### TOP / PRIMARY SIDE

UNLESS OTHERWISE SPECIFIED: DIMENSIONS ARE IN MILLIMETERS SURFACE FINISH: TOLERANCES: LINEAR: ANGULAR:		FINISH:		DEBUR AND BREAK SHARP EDGES		DO NOT SCALE DRAWING		REVISION	
NAME	SIGNATURE	DATE				TITLE: Panel single product default dimensions			
DRAWN									
CHK'D									
APPV'D									
MFG									
Q.A				MATERIAL:		DWG NO.			
				WEIGHT:		SCALE:1:5			
						SHEET 1 OF 1

**Panel dimensions**  
general tolerance +/- 0,1mm  
unless specified differently

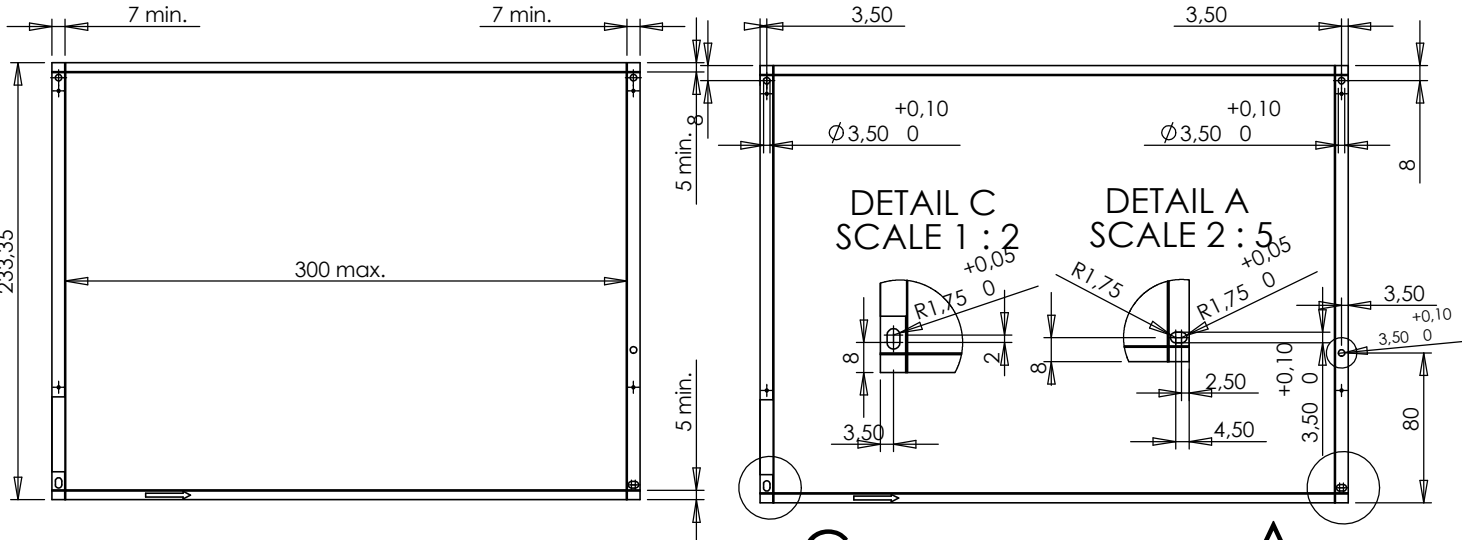
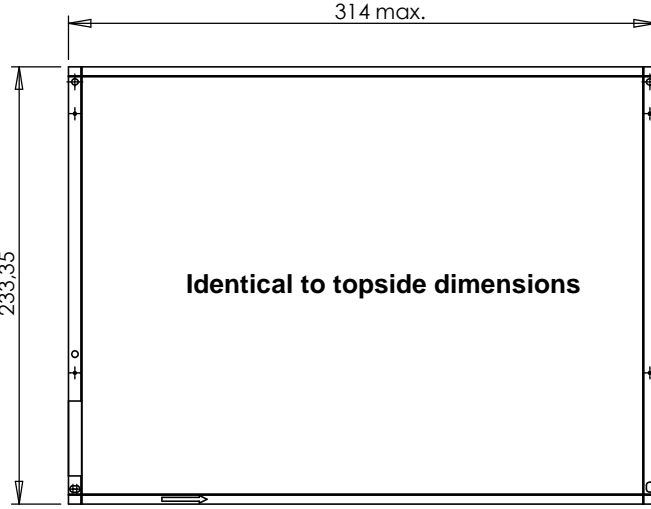
**Revision information R01 --> R02:**  
2 Holes have been added. 1 vertical oblong hole on the left break-off edge and 1 circular hole on the right break-off edge

**PCB Markings**  
general tolerance +/- 0,1mm  
unless specified differently

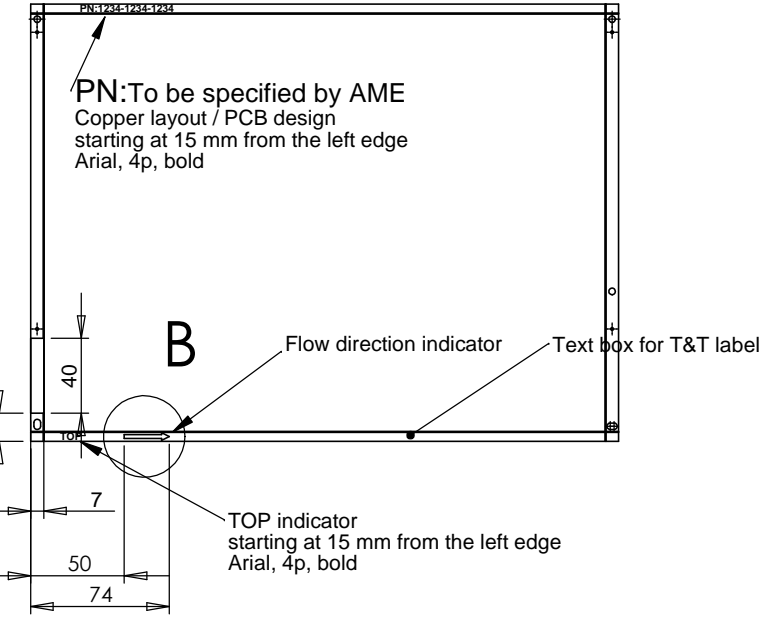
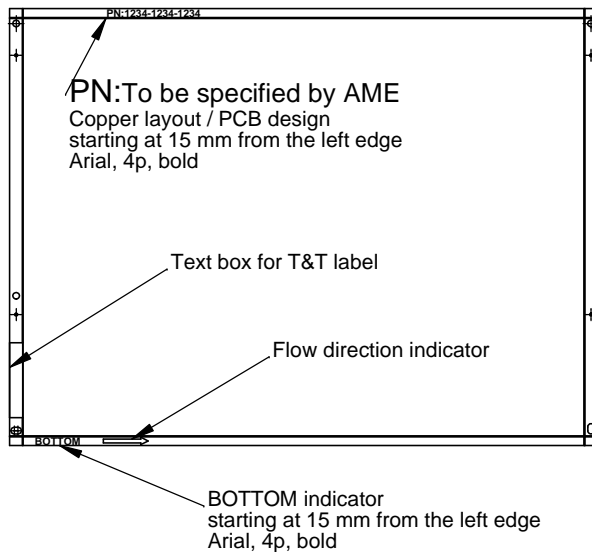
**Revision information R02 --> R03:**  
The designated box for the label position has been changed. The lines interfered with the new lasermarking process. The box should be completely filled with copper. Additionally there should be no copper stripes or bullets on the break-off edges(they interfere with barcode scanning)
